Amendment No. 1
to
AS/NZS 2430.3.6:2004
Classification of hazardous areas
Part 3.6: Examples of area classification—Laboratories, including fume cupboards
and flammable medical agents

CORRECTION

SUMMARY: This Amendment applies to Clause 5.2.2 and Figure 5.1.

FIGURE 5.1 FUME CUPBOARD COMPLYING WITH AS/NZS 2243.8 AND LABORATORY FLOOR LEVEL

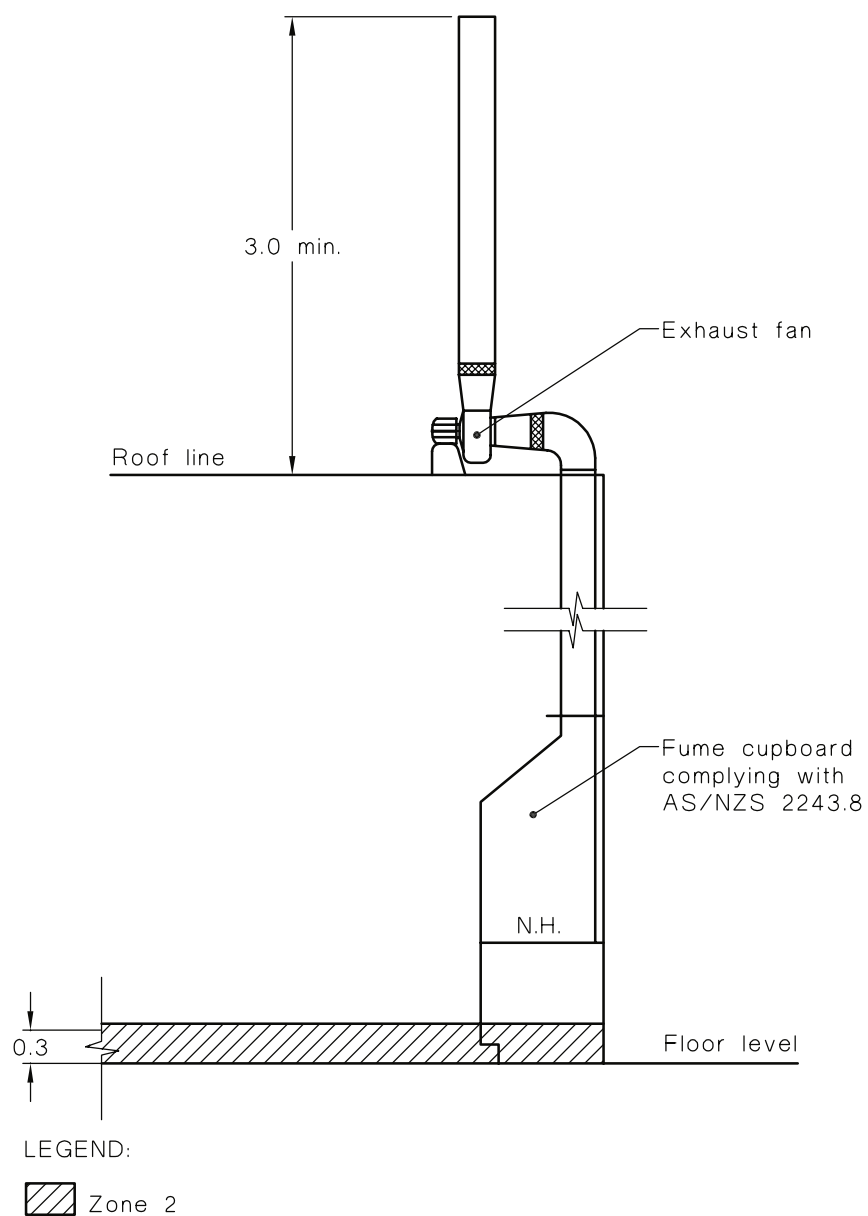
Page 7 Figure 5.1

Delete Figure 5.1 and *replace* with the following:
